RE: USYD ENGINEERING AND TECHNOLOGY – RESPONSE TO DPE COMMENTS

USYD ENGINEERING AND TECHNOLOGY

SWEPT PATH ASSESSMENT

DRAWING NO. N139961-01-03

Mark-up of N139961-01-P3

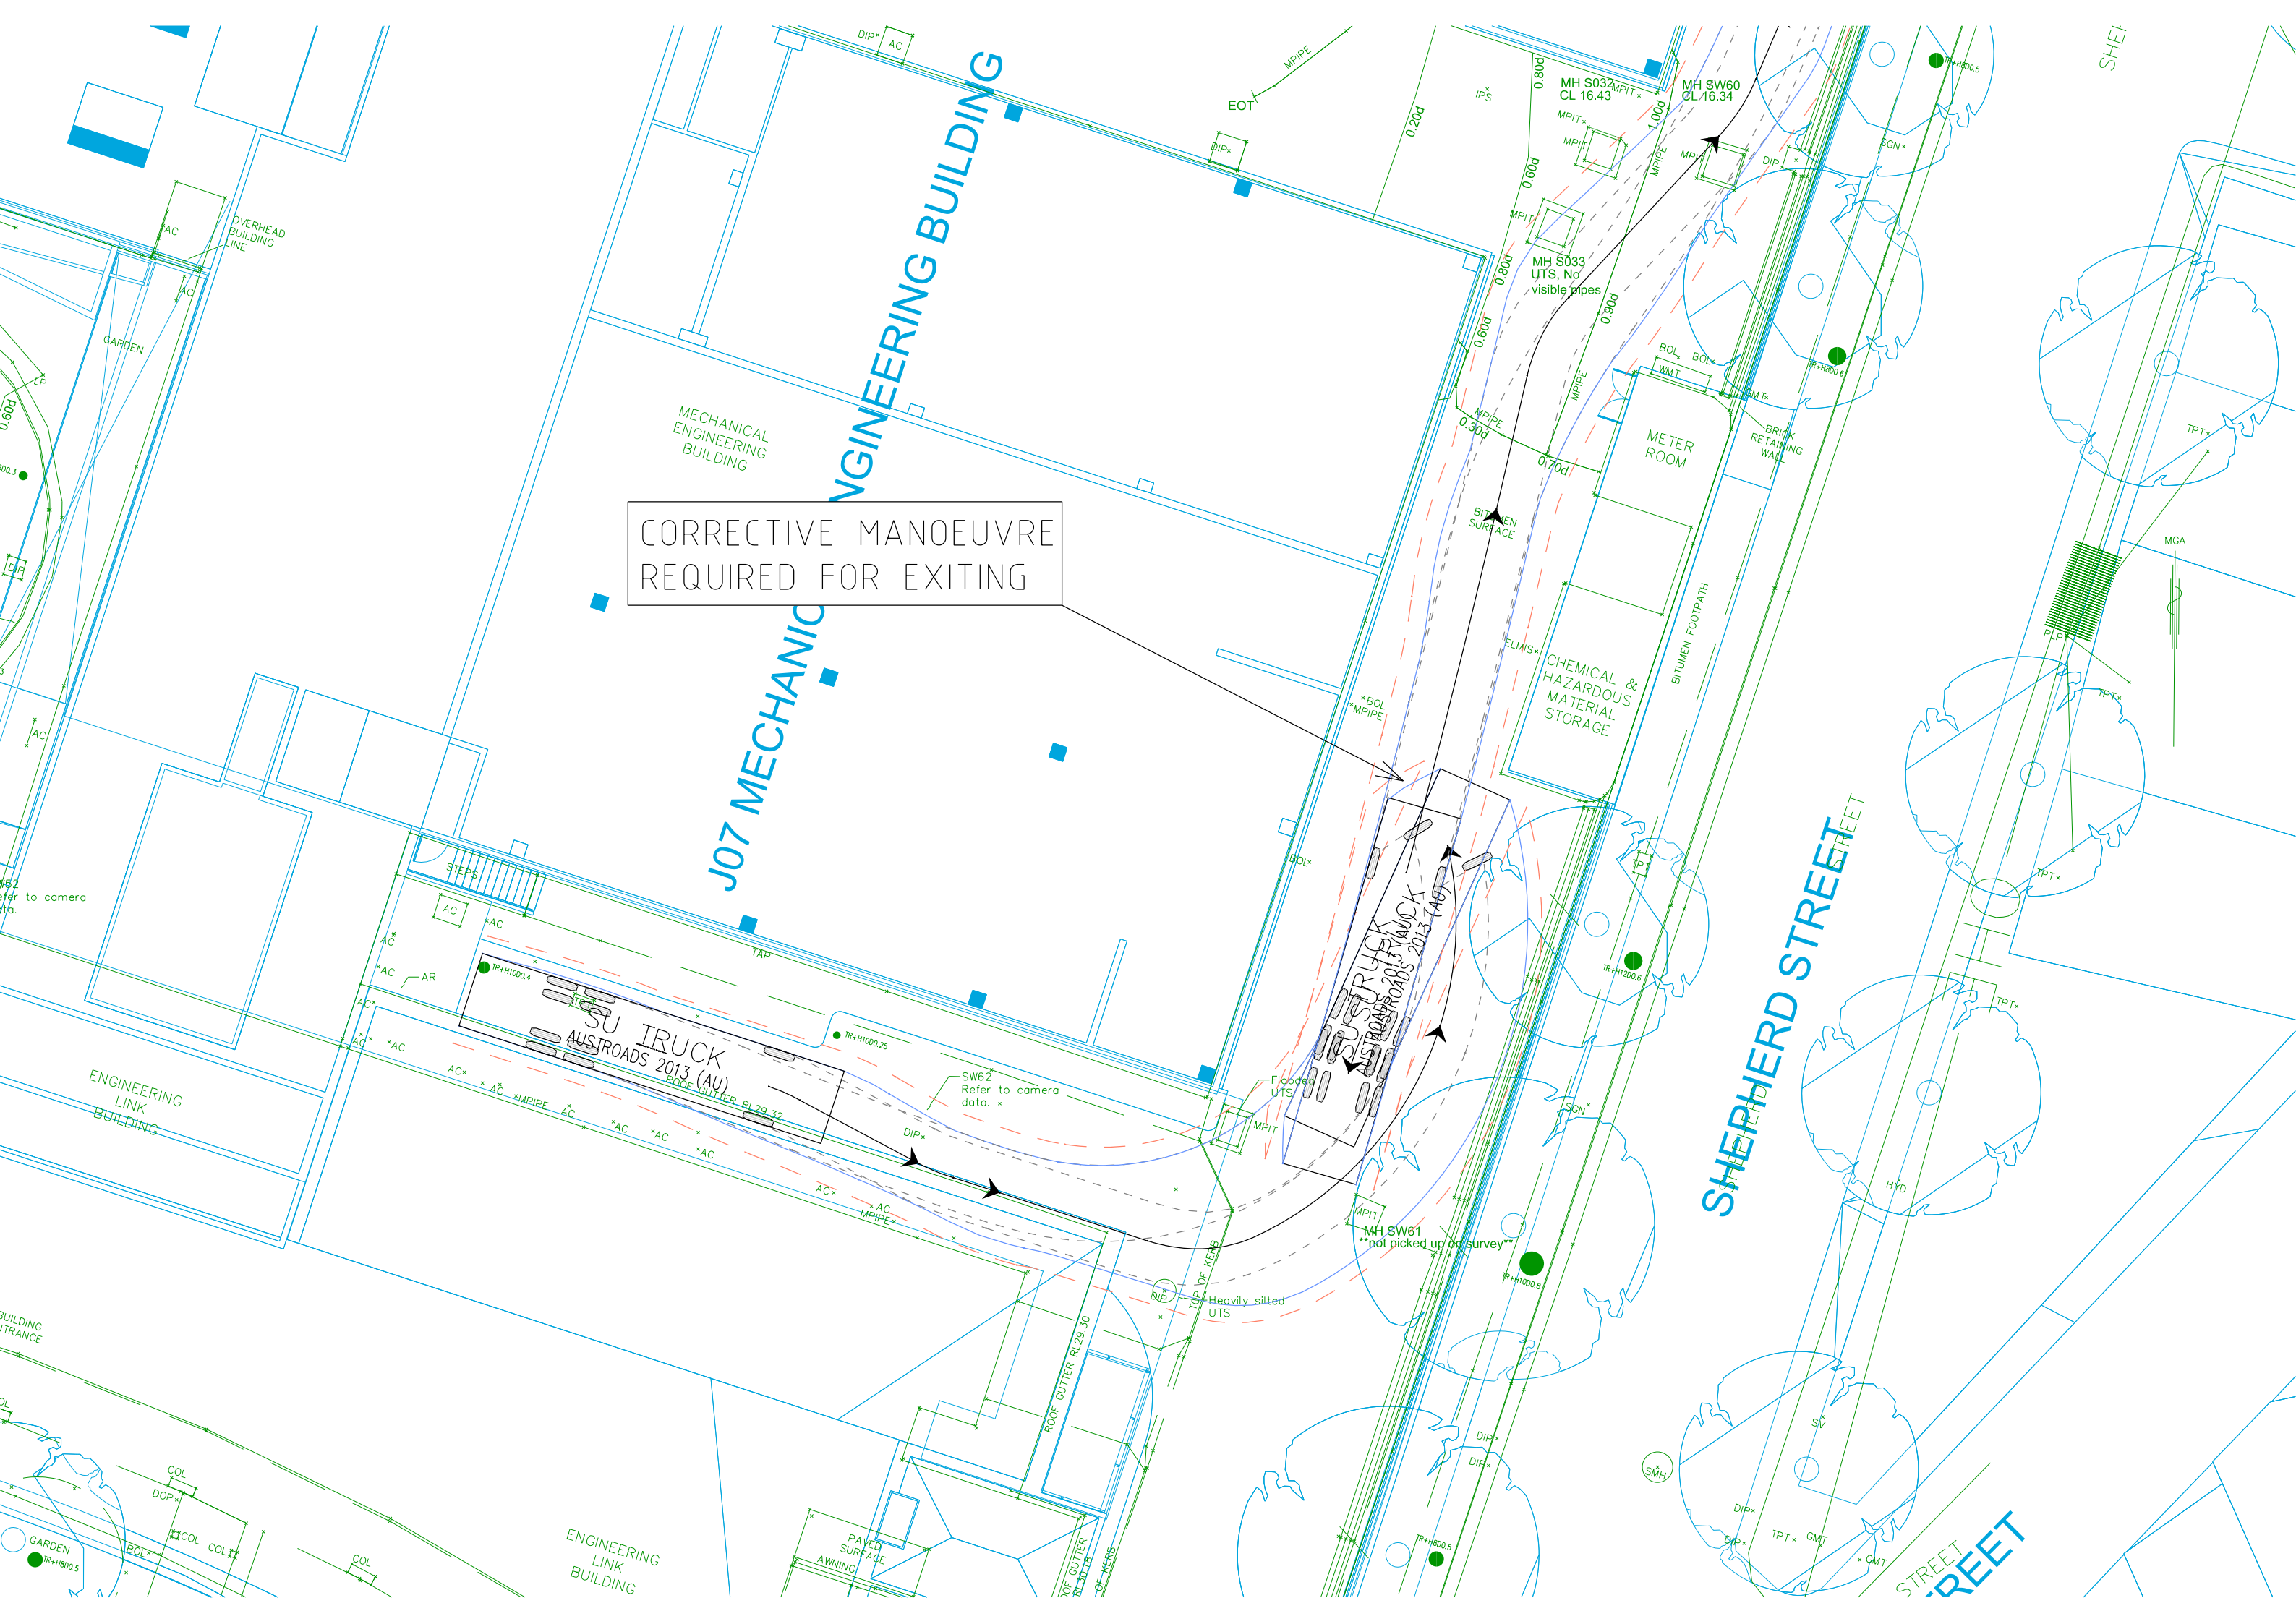
"Swept Paths for HRVs and MRVs show a number of conflicts with existing structures, including the hazardous materials storage building. The assessment does not advise how there will be resolved."

Height Clearance of Existing Structure to the East of the Retained Engineering Building (Location 01)

Chemical and Hazardous Material Storage (Location 02)

Traffic Island Adjacent to Telstra Pit (Location 03)

Bollards (Location 04)

The location had an existing canopy that restricts the height clearance along the Service Road to 3.6 metres. It is proposed that the University of Sydney will manage the height clearance issue via its procurement process, whereby the restricted height clearance is declared to ensure all suppliers delivering to the Engineering Building dock being vehicles that can clear the reduced height clearance.

It is noted that the only vehicle that may conflict with the Chemical and Hazardous Material Storage is the 12.5m HRV. As HRV and MRV vehicles exiting the site will be managed via the implementation of a Traffic Guidance Scheme previously submitted, it is proposed that the University's nominated staff that will be implementing the Traffic Guidance Scheme provide direction to HRV vehicles to perform a corrective manoeuvre to achieve a straight approach to the Chemical and Hazardous Material Storage.

The vehicle where the conflict occurs is an existing traffic island where two existing Telstra Pit is located. The conflict can be managed either via the installation of a localised ramp to allow for HRV to track over the traffic island or via cutting back the traffic island to be clear of the swept path.

The bollards identified as conflict have been removed whilst construction works are being undertaken. Replacement bollards following completion of construction will be installed in locations clear of the swept path of an HRV.
